PINE RIDGE FAÇADE JSP 16-17

Approval at the request of Acquira Realty Holdings for Preliminary Site Plan and Section 9 Façade Waiver. The subject property is located in Section 22, north of Ten Mile Road and west of Novi Road. The subject property is approximately 4.54 acres and in the B-3, General Business District. The applicant is proposing to remodel the existing façade for Pine Ridge, a multi-tenant shopping plaza, along with some landscaping improvements.

Approval of Preliminary Site Plan and a Section 9 Façade Waiver

NEW PLANTING LIST

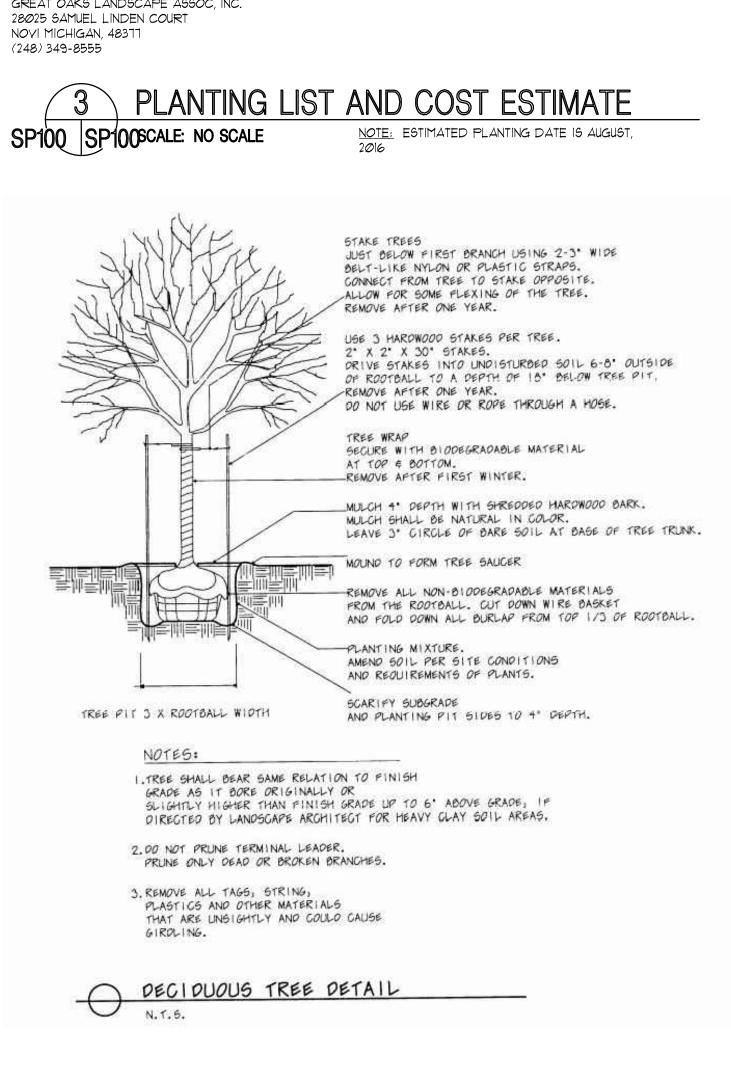
- 1. Plant list and planting detail for canopy trees are provided.
- 2. Please revise the costs of the trees to \$400 each, and the cost of the mulch to \$35/cy.
- 3. Please also add any anticipated seeding/sodding costs at \$3/cy or \$6/cy, respectively.
- 4. Please add notes stating that trees are to be installed between Mar 15 and November 15, that trees are to be guaranteed for 2 years from date of acceptance, and that any changes in tree species or location need to be approved in writing by the City Landscape Architect before they are planted.

- 3. <u>Plant List Details</u>: **RESPONSES**:
 - a. Costs of Trees shall be revised to \$400.00 each and the mulch to \$35.00/cy.
 - b. Anticipated seeding/sodding costs shall be added at \$3.00/cy and \$6.00/cy respectively

- c. Notes stating installation timing of trees and the 2-year guarantee shall be added to drawing.
- Irrigation: RESPONSE: Notes shall be added to drawings indicating functionality of irrigation system (or upgrades to make irrigation functional), otherwise manual watering of the trees shall be incorporated until they are established.

SP100 SP100scale: NO SCALE

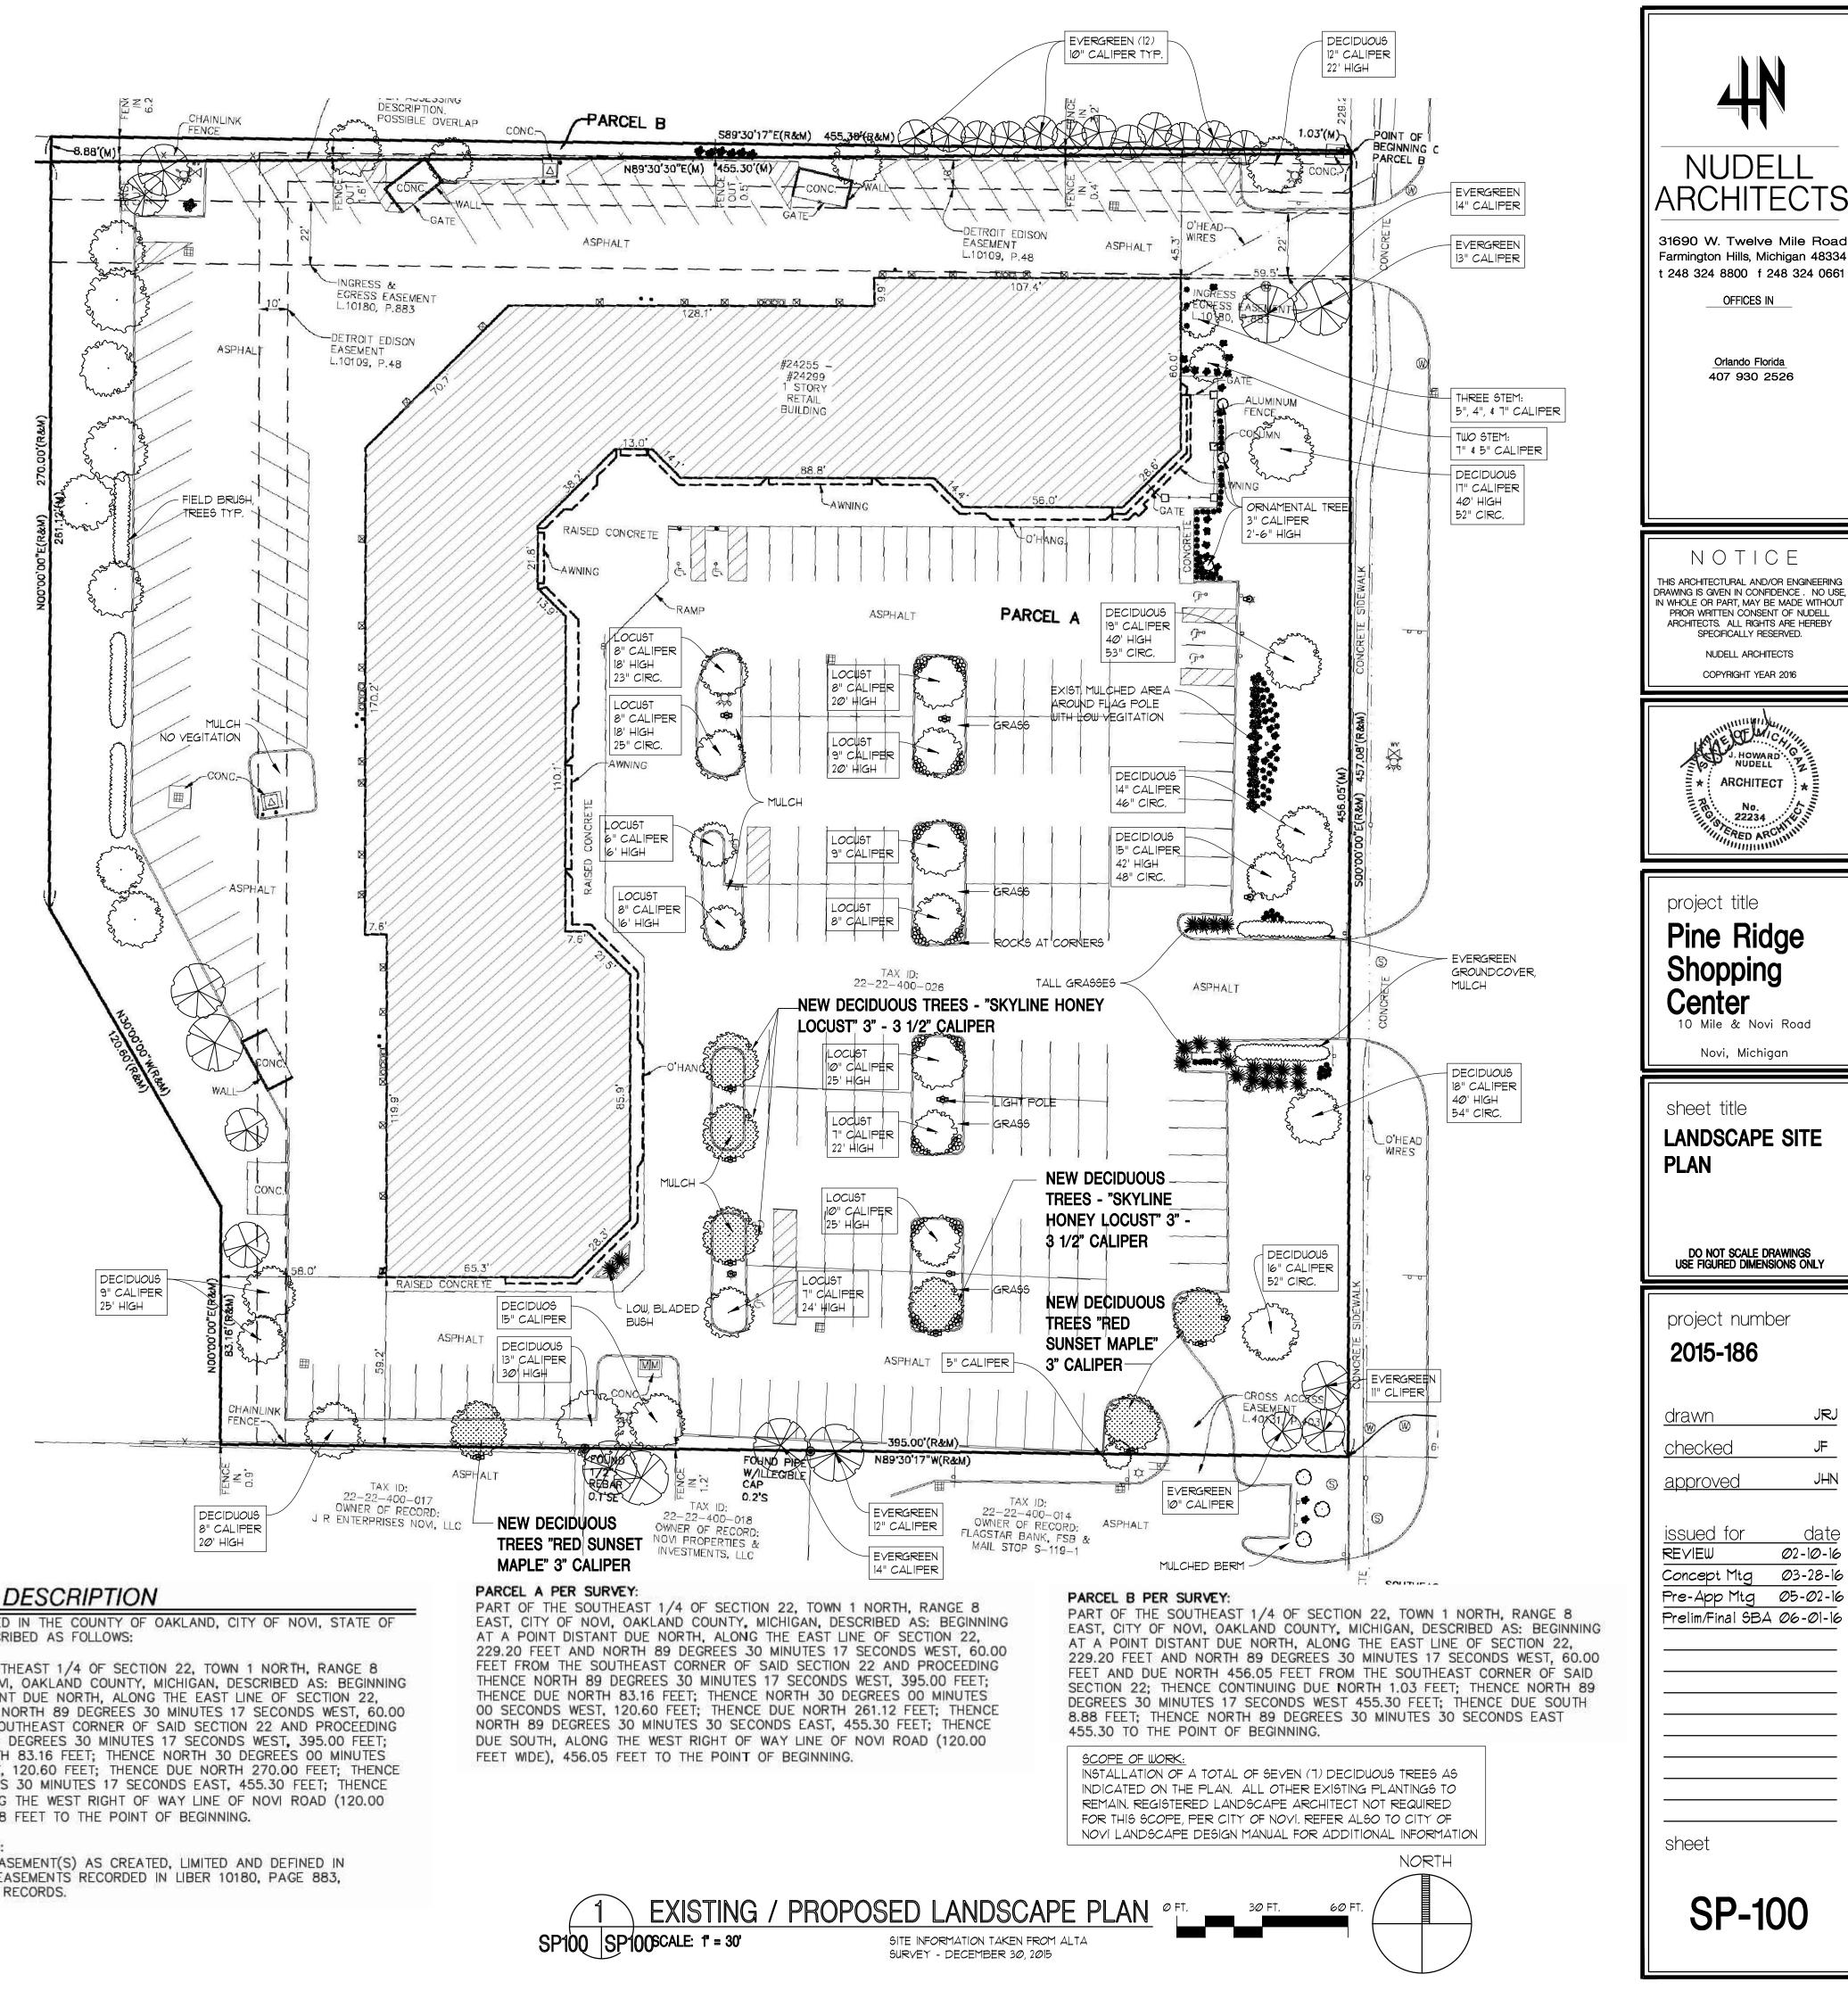
Please indicate where snow is deposited during the winter to be sure trees aren't negatively impacted by it.

- <u>Snow Deposit</u>. RESPONSE: The Site plan will be updated to indicate where Show will be deposited in order that trees are not negatively impacted.
